# PLANNING AND ZONING COMMISSION AGENDA

Regular Meeting  
Tuesday, January 13, 2015  
7:00 p.m.  
City Hall - Council Chamber  
Daniel P. Moore Community Center Complex  
1900 Billy G. Webb Drive  
Portland, Texas

# PLANNING AND ZONING COMMISSION ACTION ITEM

# PLANNING AND ZONING COMMISSION ACTION ITEM

## SITE PLAN

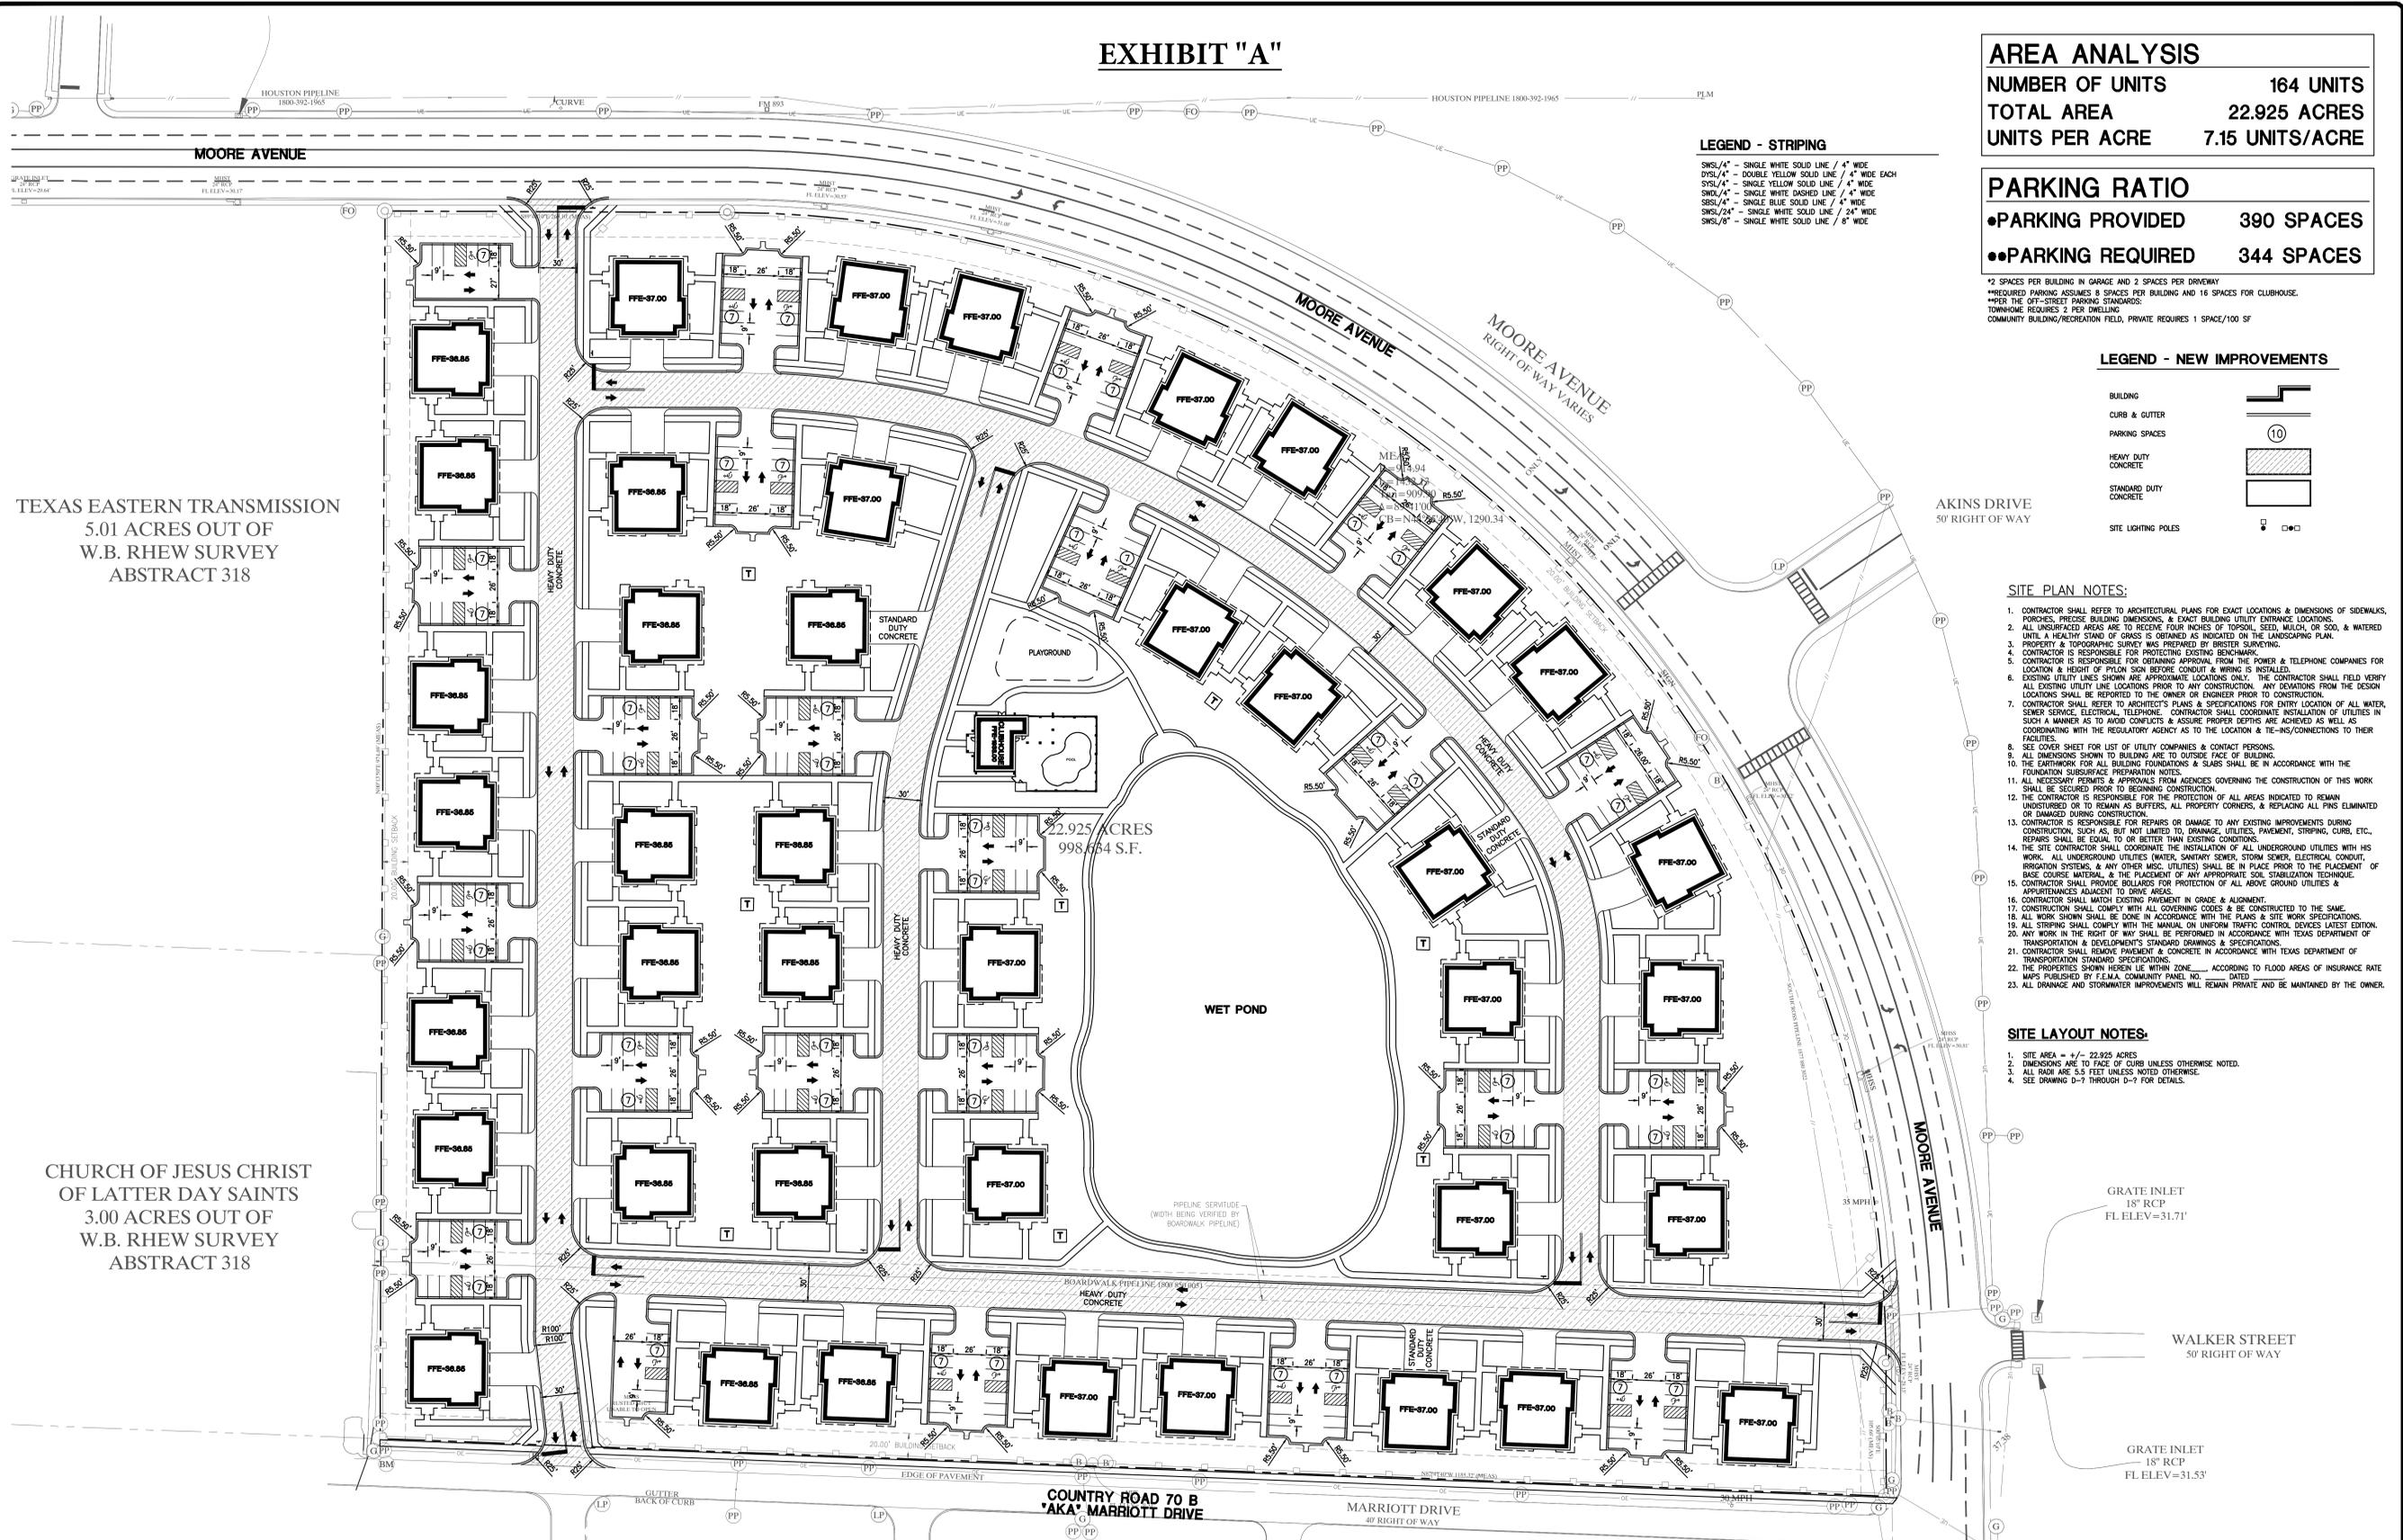
The applicant is proposing 41 4-plex buildings staggered throughout the development. Given that the 4-plexes are designed to mimic single-family housing, City Staff recommended that the applicant design a site plan resembling a high-end neighborhood with the concept that a multifamily project that visually appeared like a high-end single-family subdivision would be innovative and appealing and thus meeting the PUD requirements. In the applicant’s effort to do so, it is City Staff’s judgment that the proposed site plan more closely resembles tract housing or the Bridge Pointe Landing Apartments. Given that each of the buildings’ exterior elevations is similar, this tract housing feel is magnified.

After the applicant’s initial submittal, City Staff recommended that the applicant revise the site plan in an attempt to add innovation as required by the UDO. The applicant noted after the initial submittal via email on December 17 that it is “looking at making distinct neighborhoods

that have different looks and feels.” The applicant subsequently declined to do so. The resubmittal of the site plan resulted in generally every other building being shifted five feet in an attempt to create a staggered look throughout the project. Even with these revisions, City Staff’s conclusion remains unchanged that the site plan lacks the desired innovation required in a PUD. City Staff does not believe there to be any conditions that could be added to the proposed ordinance that would rectify this concern without a complete redesign of the site plan.

In reviewing the application materials and the approval criteria, City Staff’s judgment is that the project as proposed does not meet the innovative requirements for a Planned Unit Development. While there is little doubt that the applicant’s intention is a high quality development, the creativity or unique characteristics that are imperative in a PUD miss the mark in this application. The applicant has even noted via email on December 29 that “I think (the development team) ha(s) done a poor job on visually representing the look and feel of the development.”

City Staff believes that the site layout must be revised to more closely resemble a higher-end single-family residential neighborhood in order for PUD approval to be considered. This could be done by clustering buildings together and by creating landscaped cul-de-sacs, medians, or boulevards throughout the development. Any of these methods could be utilized to help avoid a tract housing feel similar to Bridge Pointe Landing Apartments.

DRAWN DJG
CHECKED LMC
ISSUED DATE 12-22-14
ISSUED FOR REZONING
PROJECT NO. 14-390
FILE SITE (CLEANED UP 12-22-14)
SHEET <b>C-1</b>

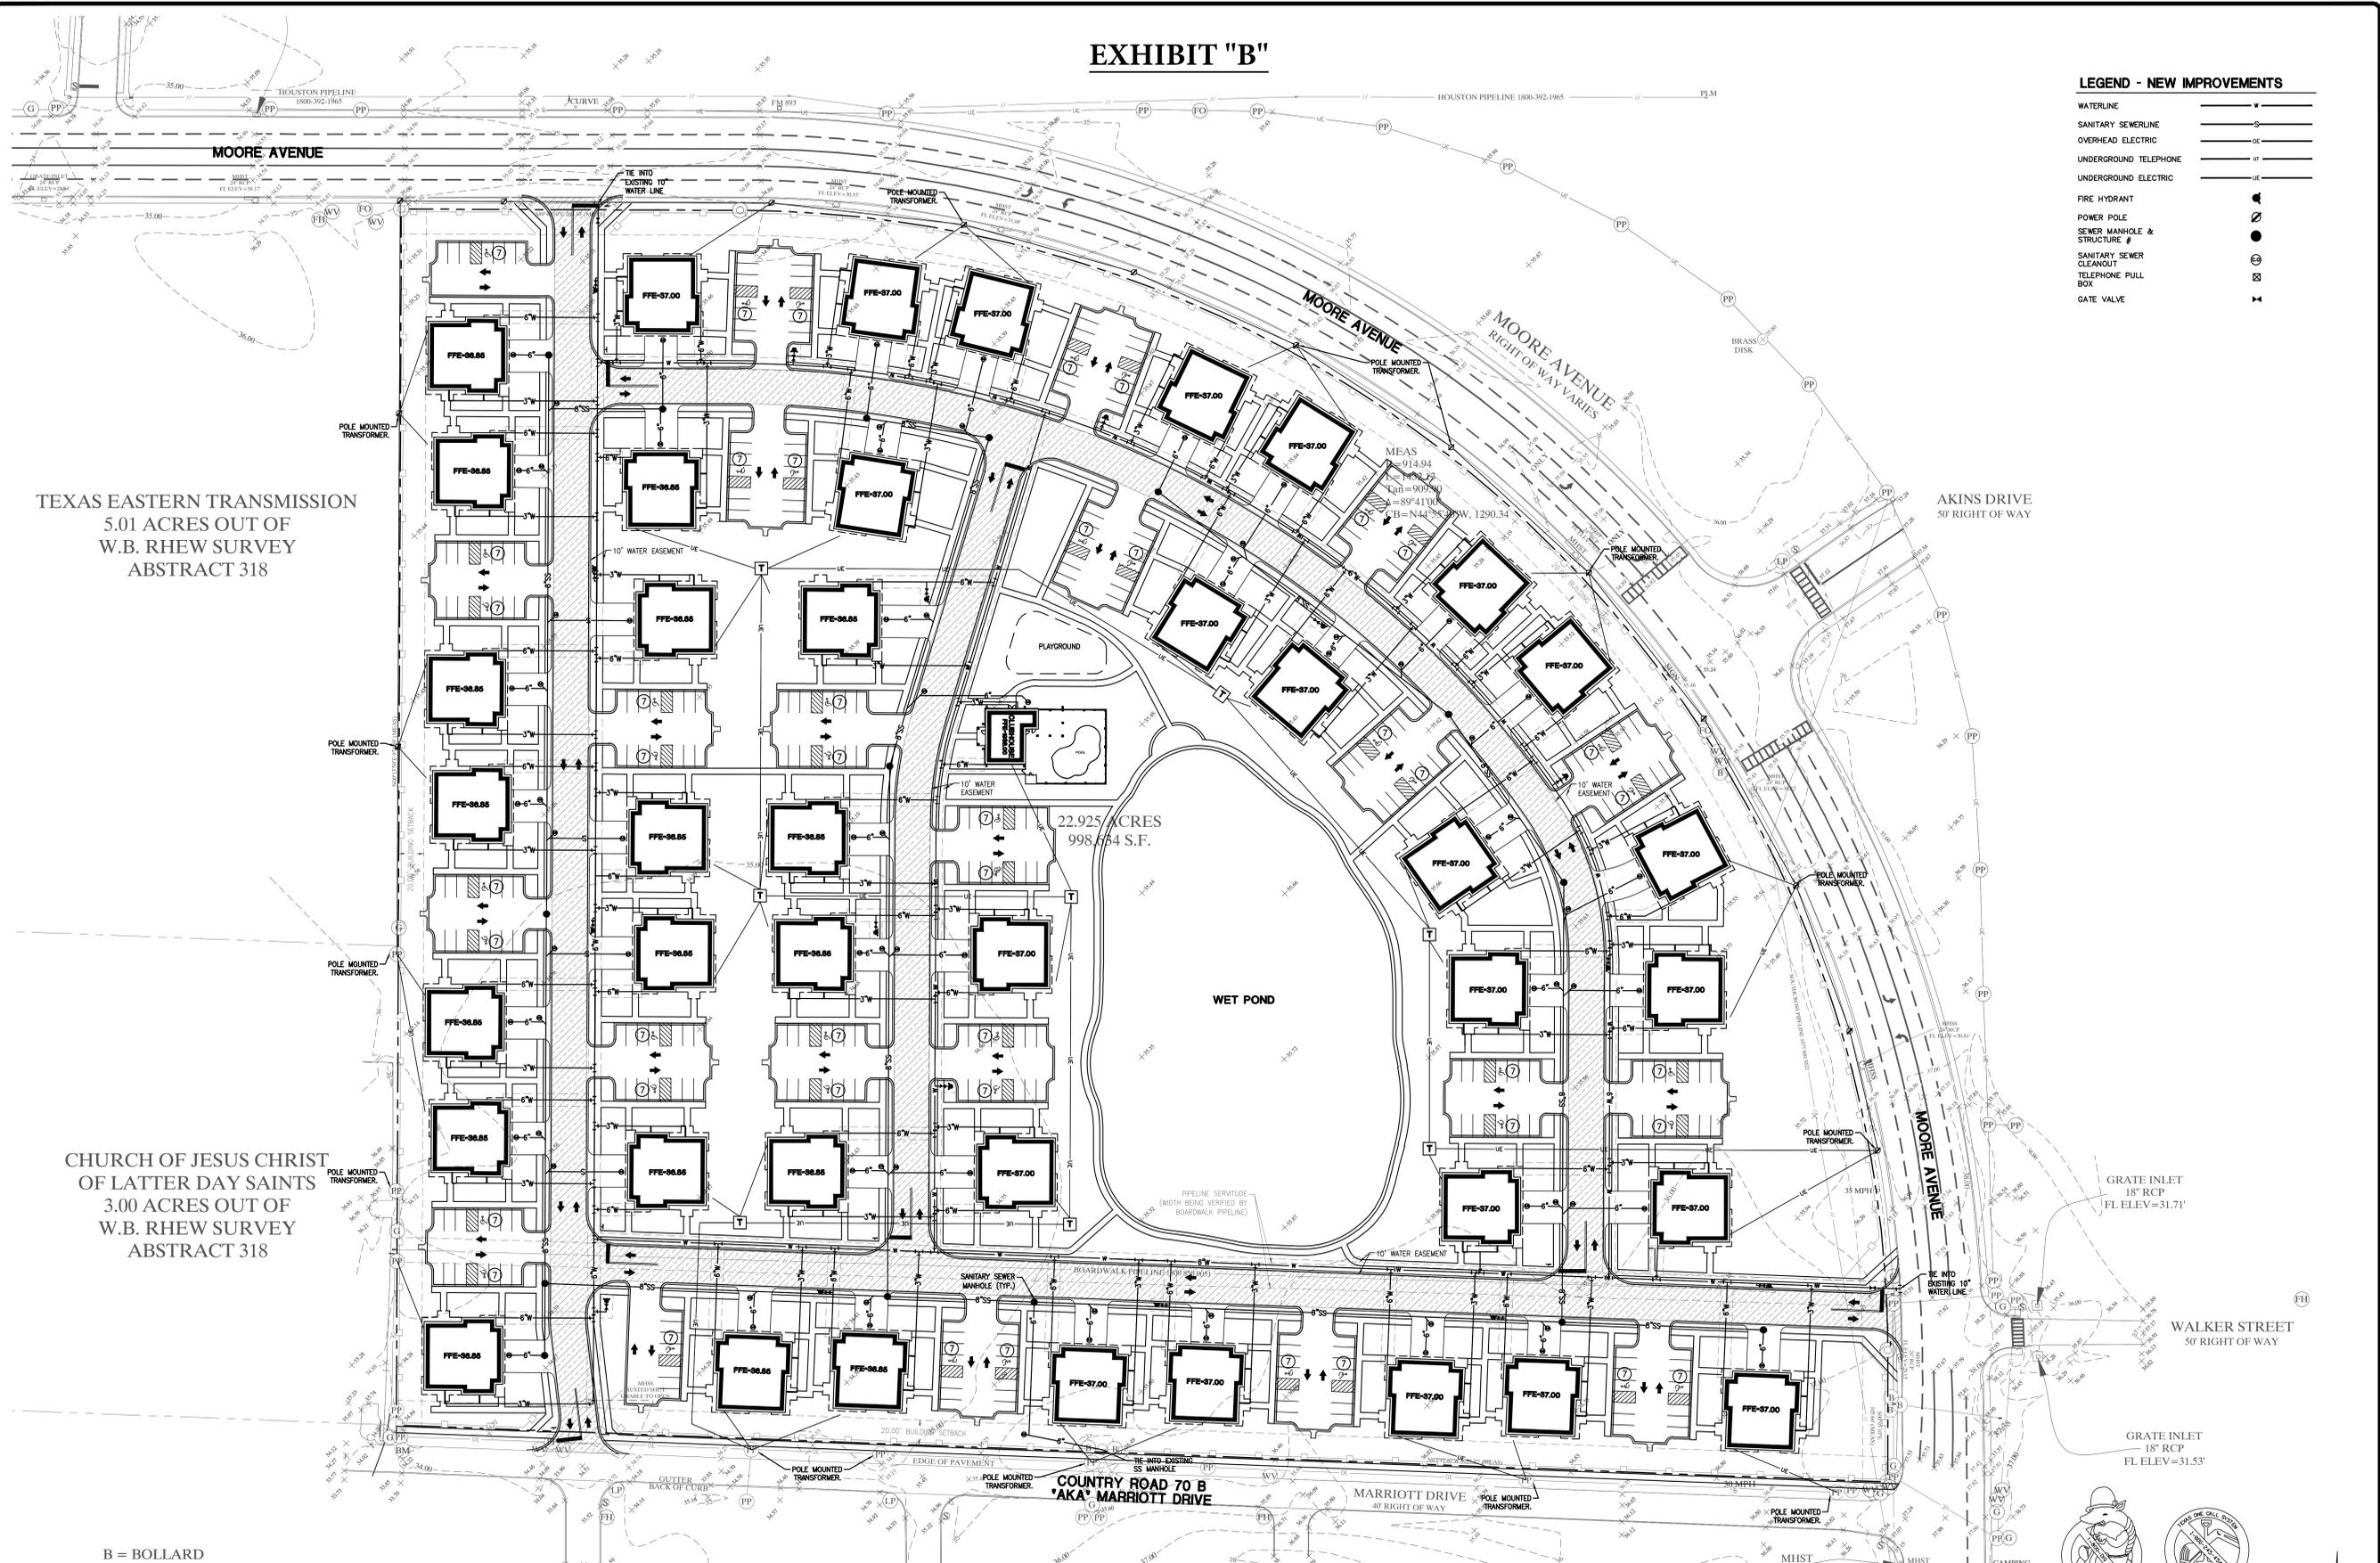
screen the complex from adjacent roadways. The site plan proposes a wood fence with masonry columns along Moore Avenue and a wood fence on its western side. The project is un gated. City Staff recommends that the fence along Moore Avenue be wrought iron with masonry columns.

7. Exhibit "C" shall be modified to depict a wrought iron fence with masonry columns spaced at maximum fifty (50) foot intervals along Moore Avenue and Marriott Drive.
